DEVELOPMENT REVIEW COMMITTEE (DRC) COMMENT REPORT

Project Name: 124 Hendricks Isles, LLC / 124 Hendricks Isle

Case Number: R15037

Request: Site Plan Level III Review: Waterway Use / Six (6)
Multi-Family Units

Site Plan &
Data Table

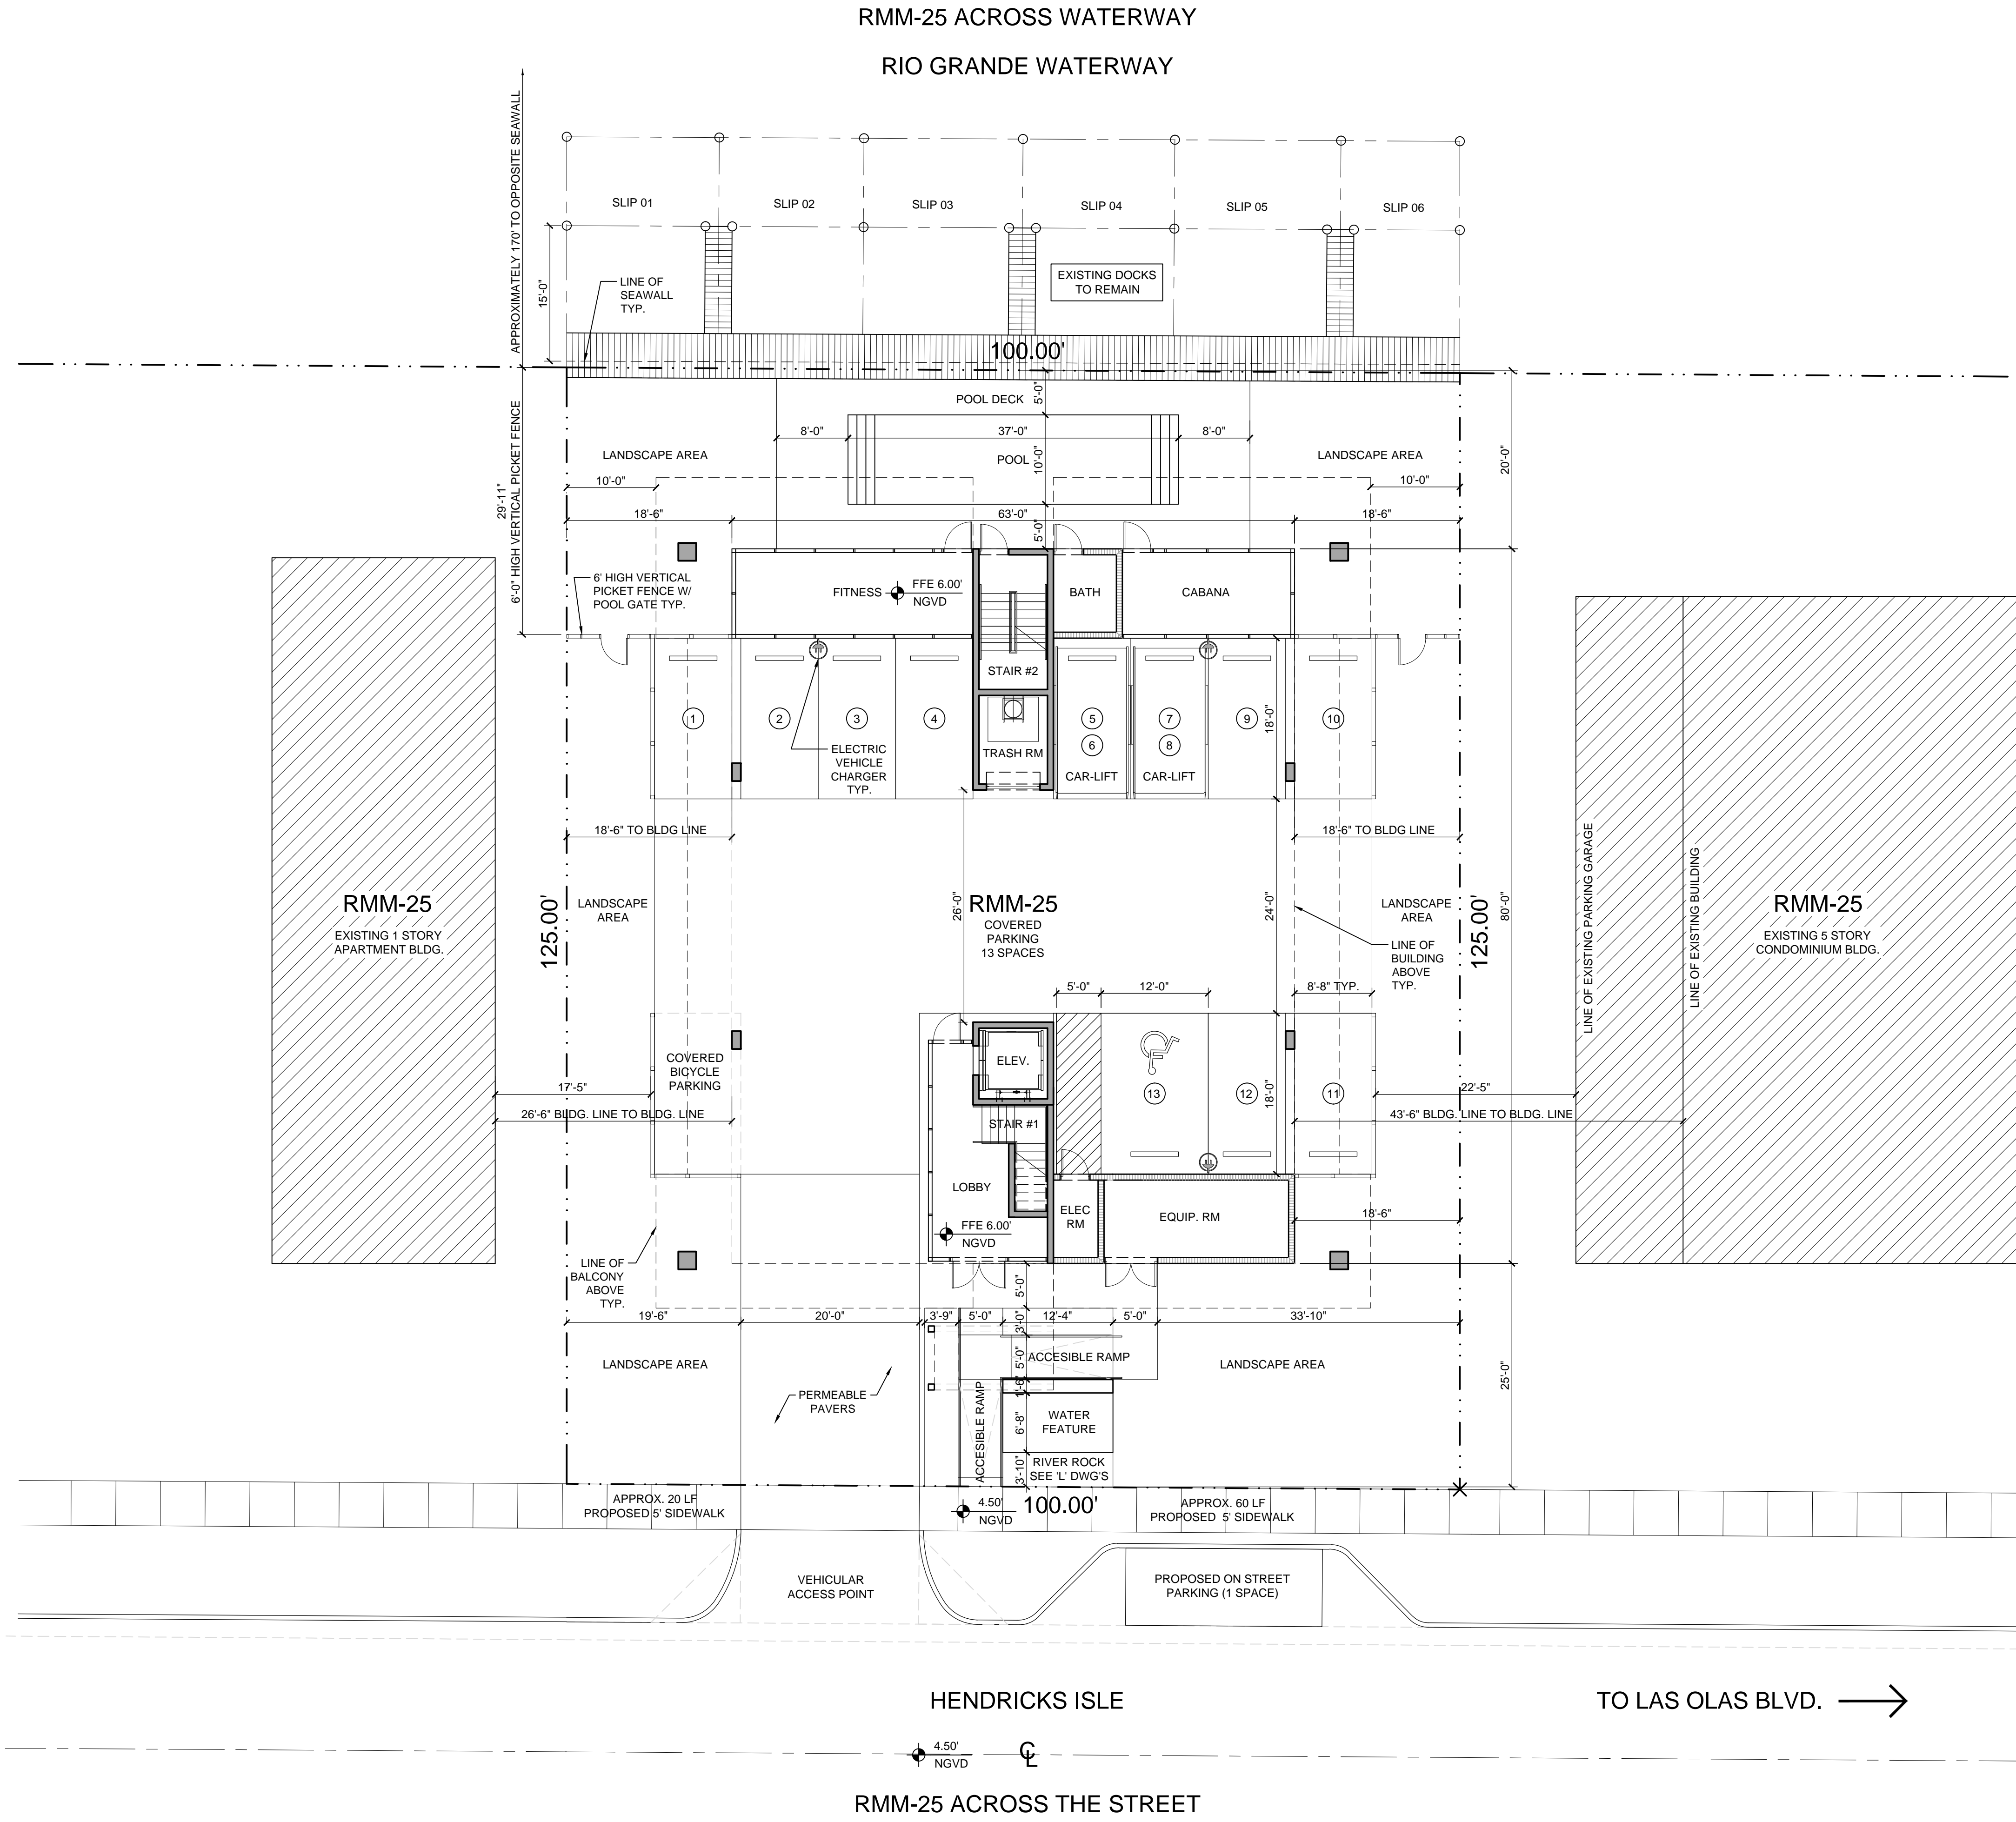
4. Label the Hendricks Isle existing 30' half Right-of-Way width, adjacent to the property, on Sheet A-101 (Site Plan & Data Table) and Sheet C-3 (Paving-Grading-Drainage Plan and Notes).

- d. Provide a pedestrian walkway from the street to the waterway area.
- 8) Provide the following changes to the site plan and elevations:
 - a. Dimensions from the property line to the entry trellis.

Building
Elevations

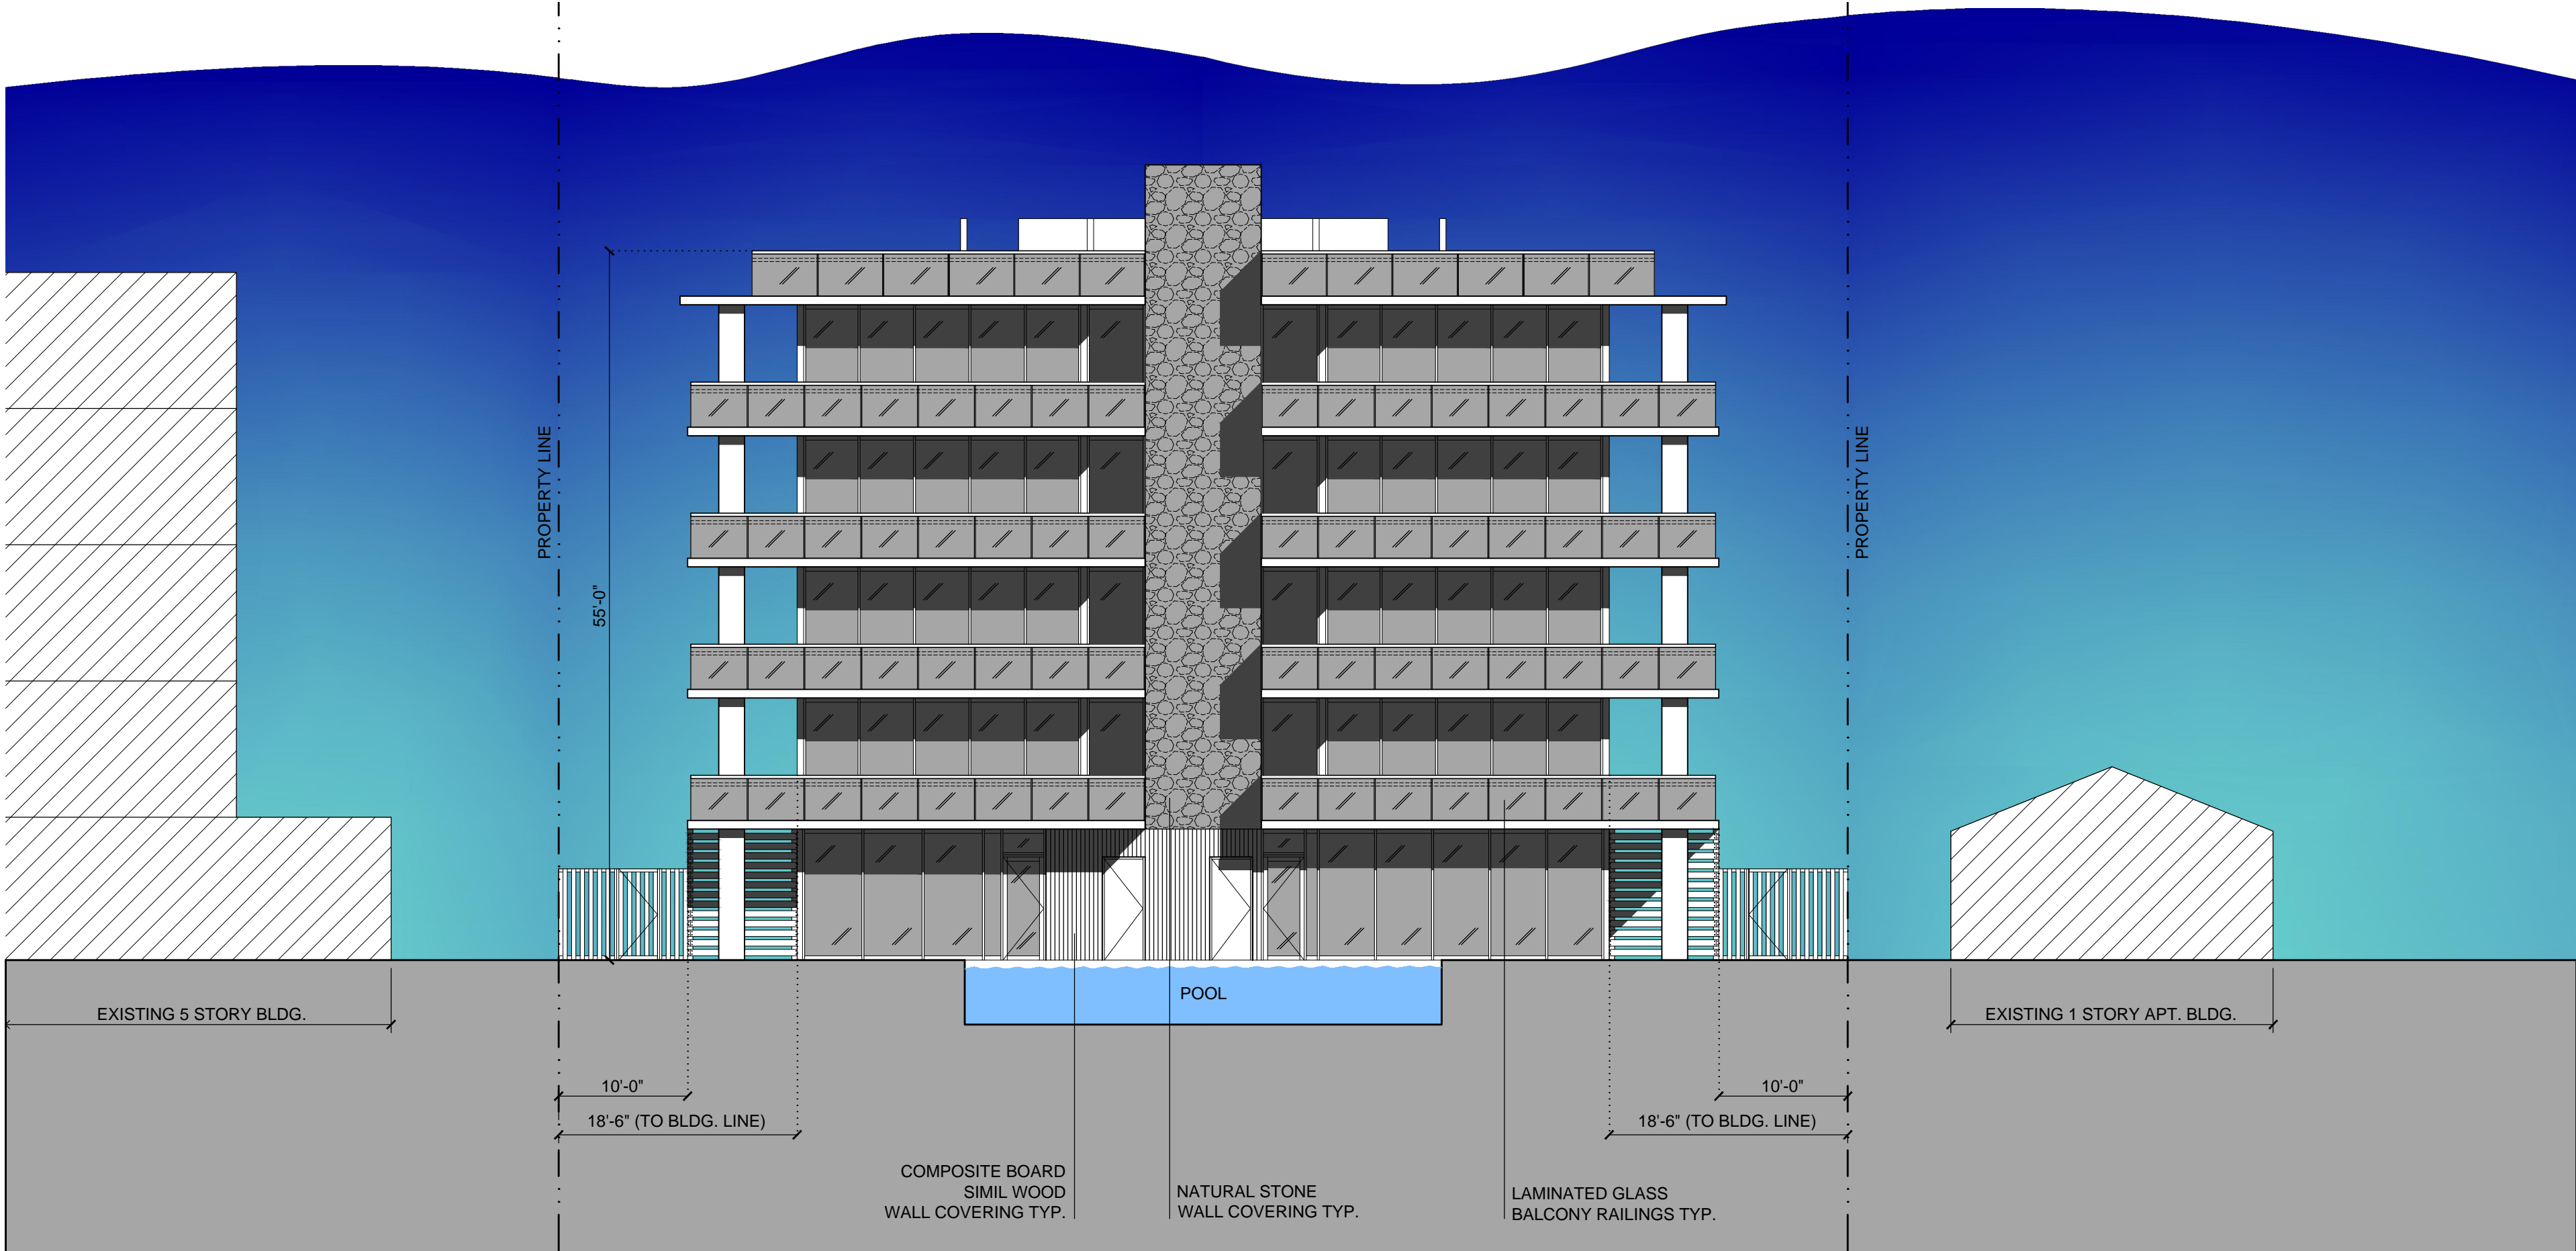
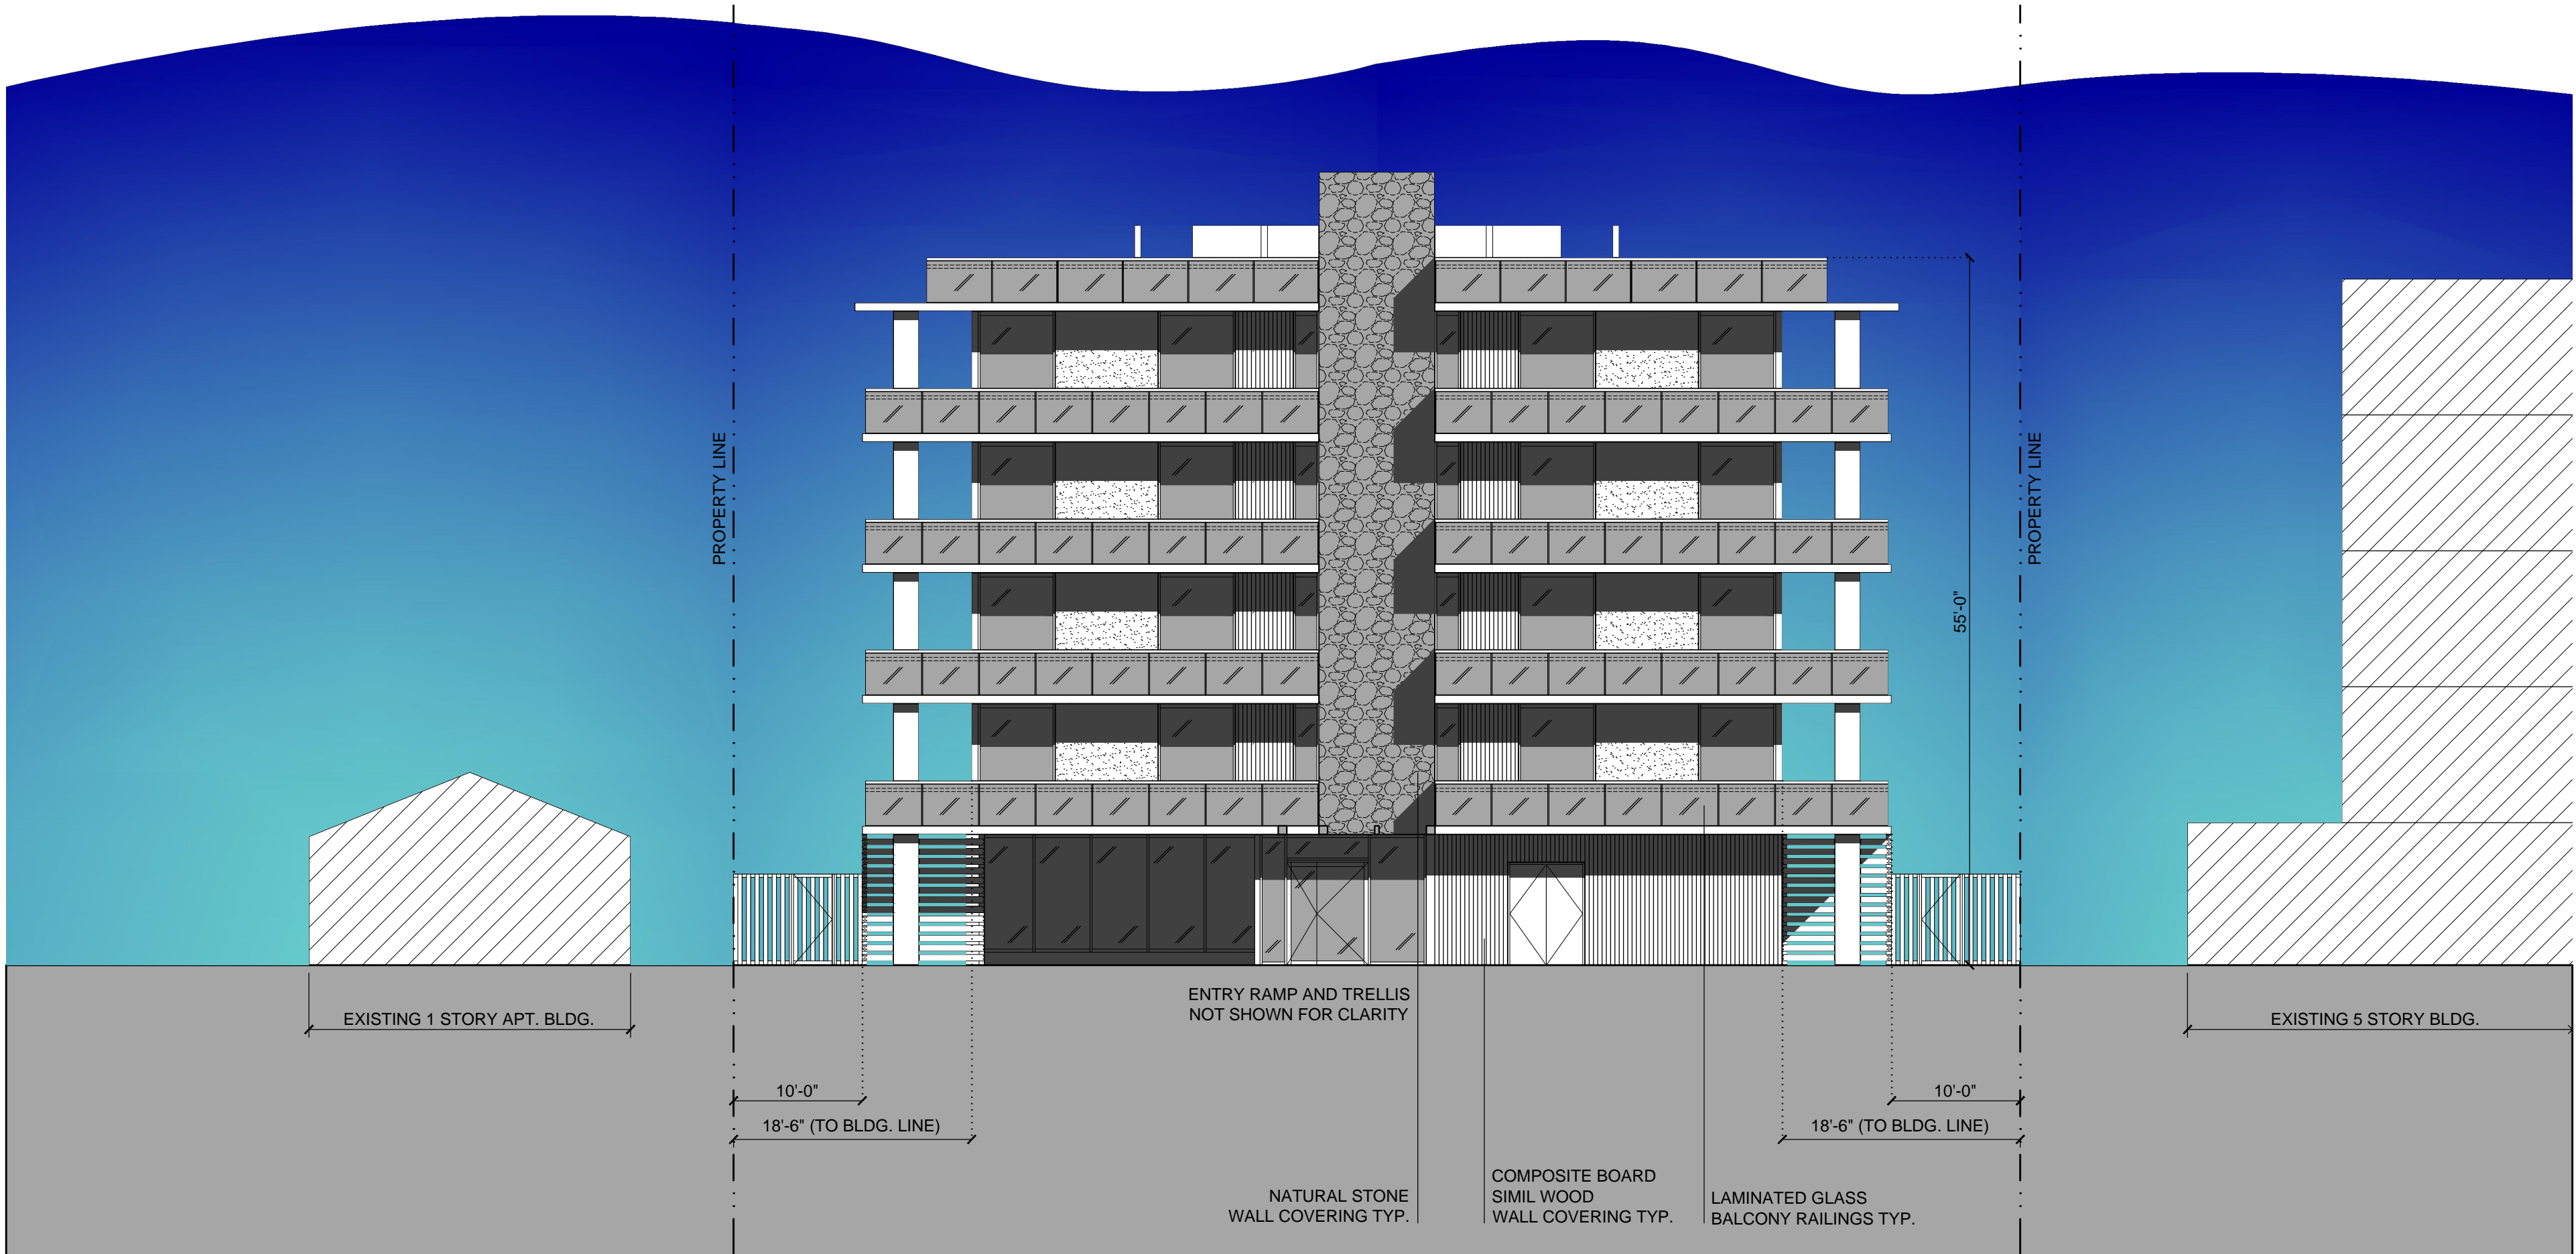
8. Sheet A-202 shows a passenger vehicle outline relative to the height of the Covered Parking area; provide the vertical clearance dimension for the Covered Parking area, and verify that the proposed Car Lift (per Sheet C-1) can be accommodated within this vertical clear dimension.
